**Department of Energy**

On January 21, 1994, the Secretary of Energy forwarded the Implementation Plan for Defense Nuclear Facilities Safety Board Recommendation 93-5 regarding the waste characterization program for high-level nuclear waste storage tanks at the Hanford Site.

Incorporation of final Board Staff comments into the Implementation Plan could not be completed prior to its release. The Implementation Plan is now revised to incorporate these comments. Errata pages and corrected text are enclosed.

Recommendation 93-5 Implementation Plan

Figure 6. Rotary-Mode Sampling.

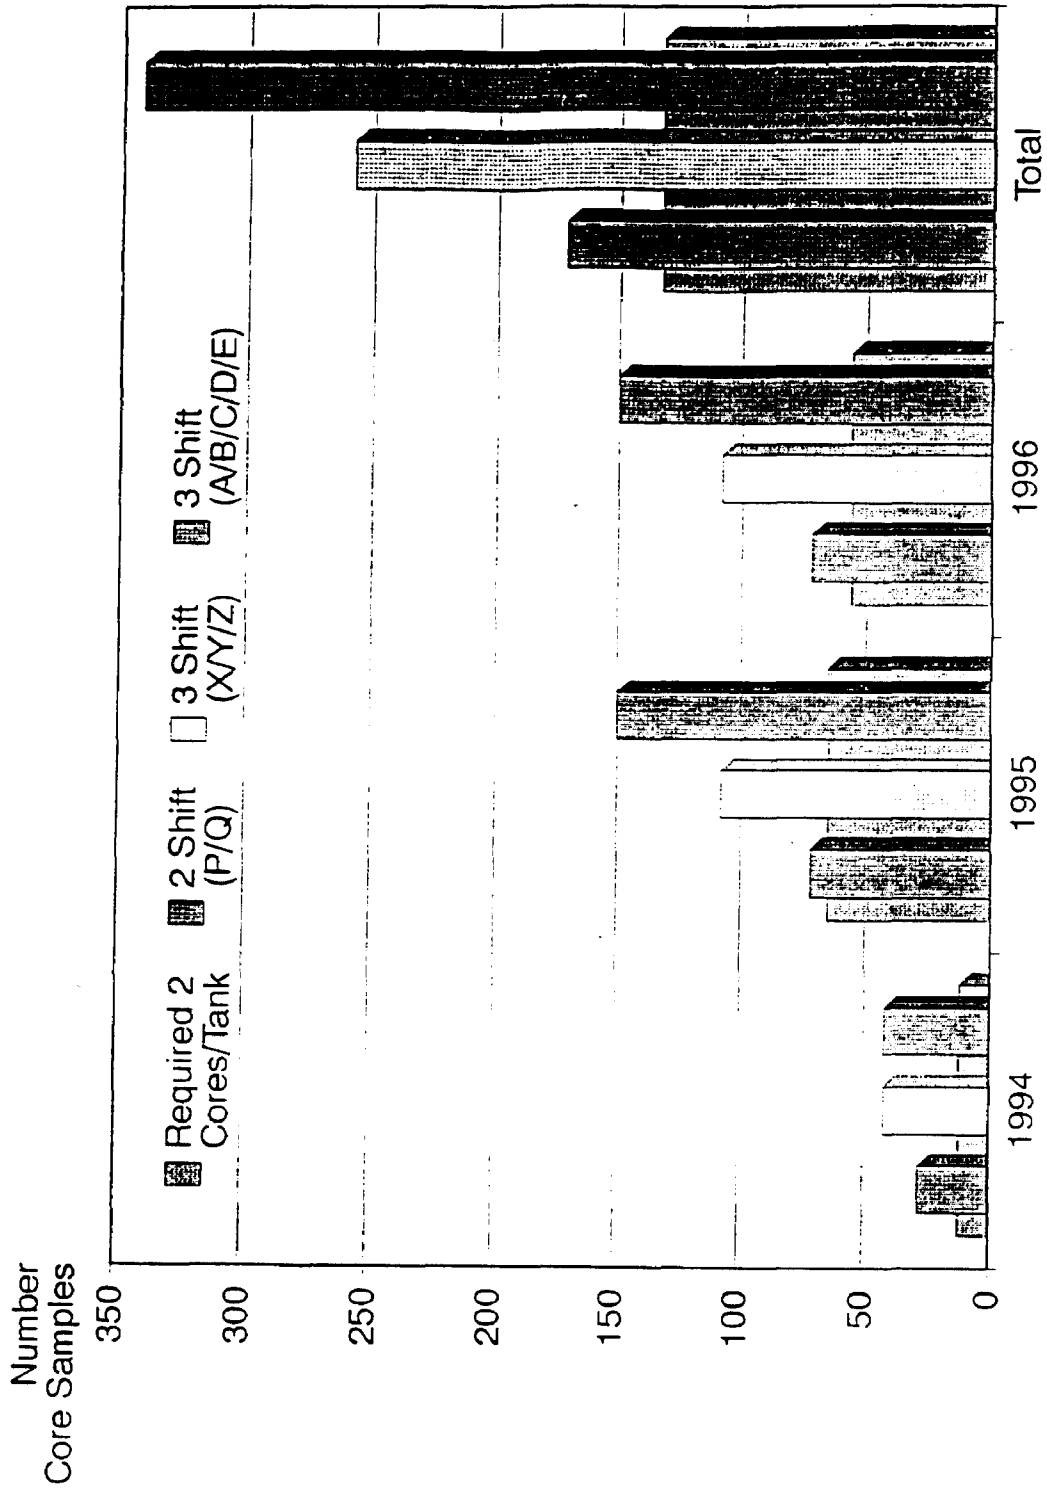
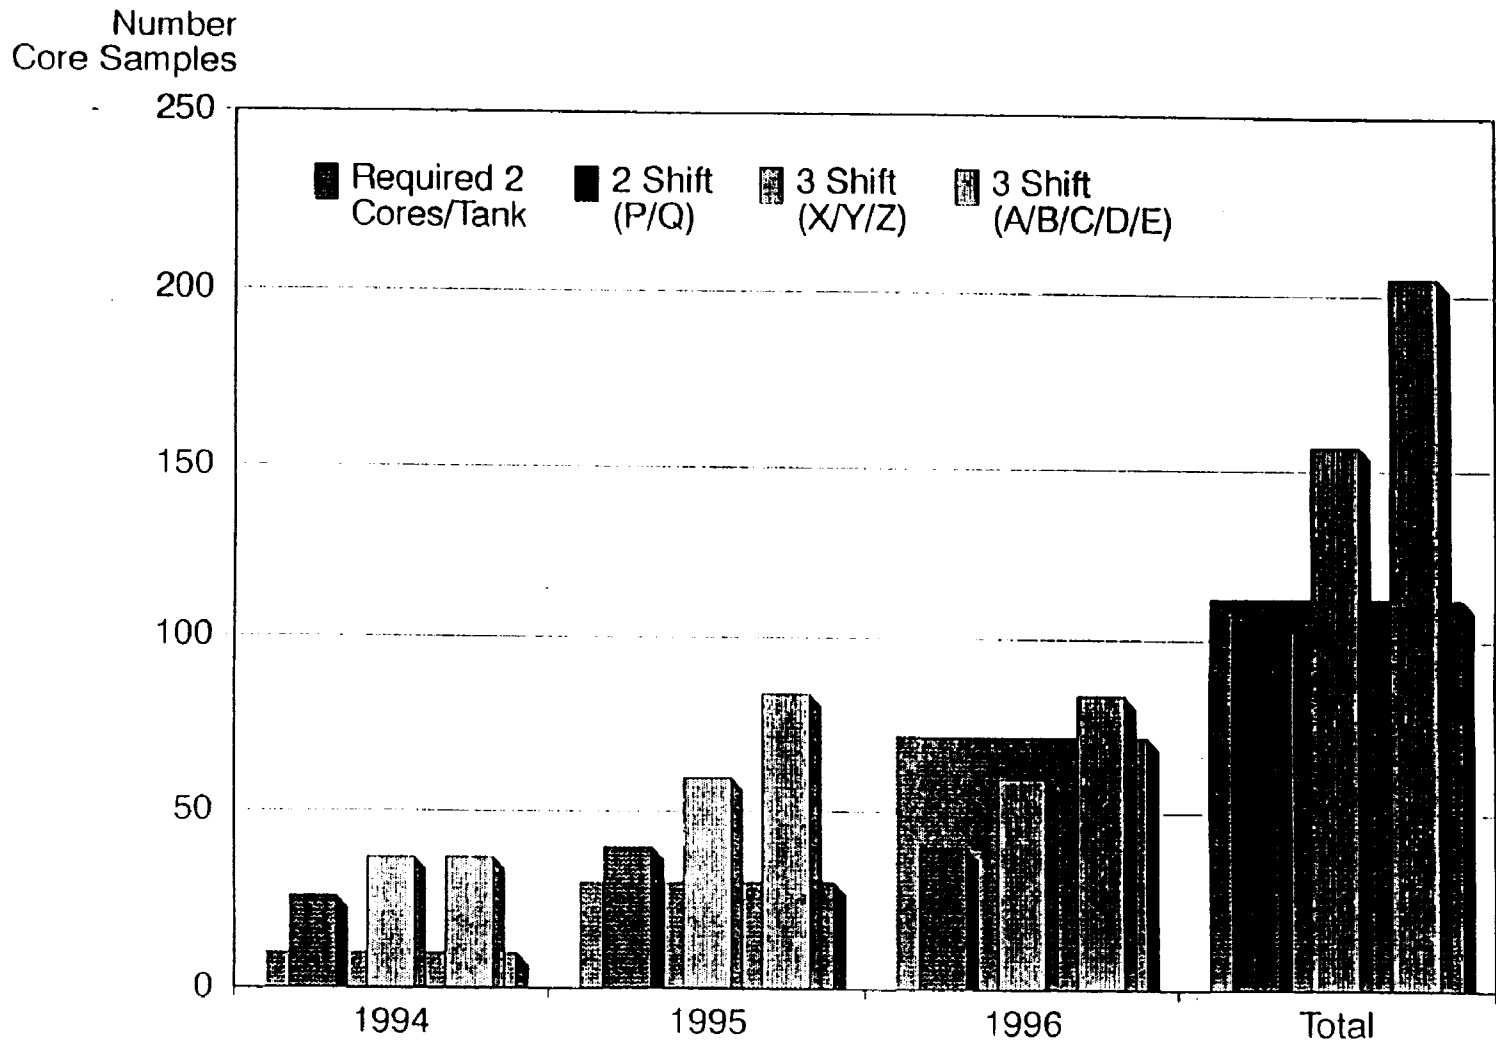
PAGE	COMMENT	NATURE OF CHANGE
32	4	Explanation of Figures 6 and 7 added.
38	1.c	Actions to improve push mode sampler noted.
40	3.d	Commitment 3.2 strengthened by adding a deliverable of a plan to resolve the findings of the review.
41	3.e	Language of Commitment 3.11 changed to make it clear that sampling trucks will be available for use on the due date.
43	3.f	Scope of study in Commitment 3.19 increased to cover administrative issues and plans to resolve them.
44	none	Changed Commitment 4.1 from January 1994 to February 1994 due to late delivery of stakeholder comments.
45	none	Changed Commitment 4.1 from January 1994 to February 1994 due to late delivery of stakeholder comments.
48	2.a	Language changed to improve consistency with Commitment 5.13.
50	3.g	Due date of Commitment 5.7 moved up from October 1994 to August 1994.
52	3.h	Added Commitment 5.14 to have the PAS-1 Casks ready to use by January 1995.
